PRODUCT CHANGE NOTIFICATION

PCN-000493

Date: 24MAY2019

Part Number(s) Affected: SDC36C.TCT	Customer Part Number(s) Affected: ☒ N/A
---	--

Outline Drawing - SOT23-3L

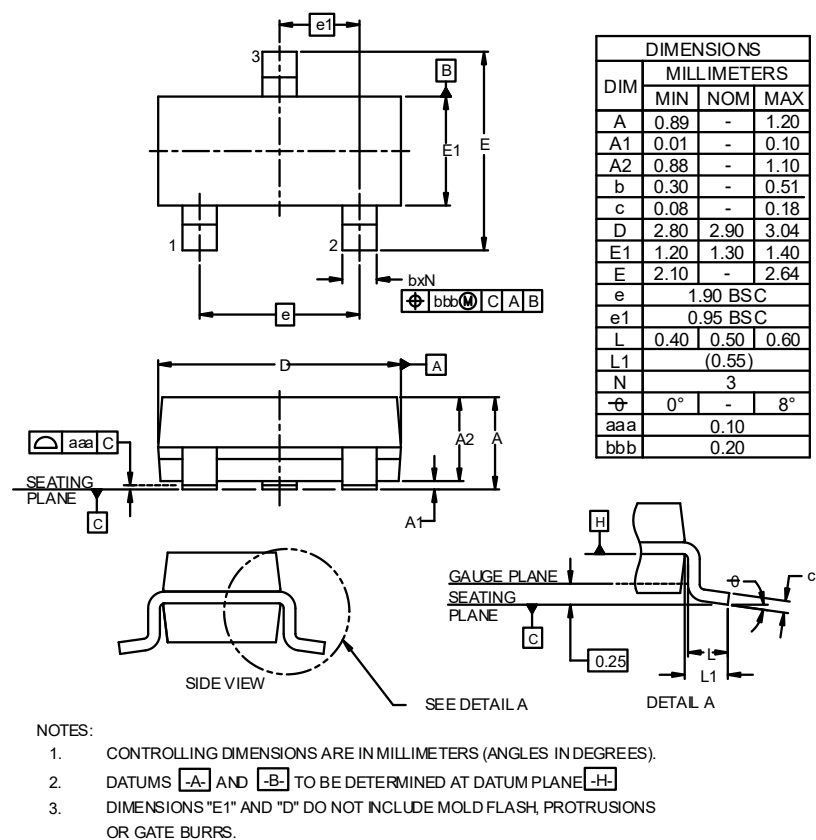
POD Change	
DIM	Max (original)	Max (modified)
A	1.12mm	1.20mm
A2	1.02mm	1.10mm
